# Errata for TLC27L2, TLC27L2A, TLC27L2B, TLC27L7 Data Sheet Literature Number SLOS052 (Revision D)

# 1 Erratum #1: Figure Correction

Figure 1. Corrected Application Illustration

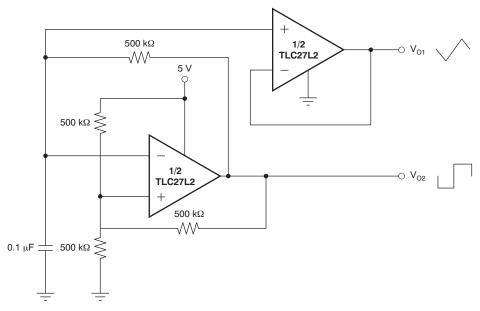
The input terminal polarity of the lower op amp shown in Figure 44 is incorrect.

As printed in the published product data sheet (literature number <u>SLOS052D</u>), the input polarity of the lower op amp shown in Figure 44 (page 30) is incorrect. The input polarity is correctly illustrated in Figure 1.

Ensure that any board designed for this device is properly configured for the correct pin placement.
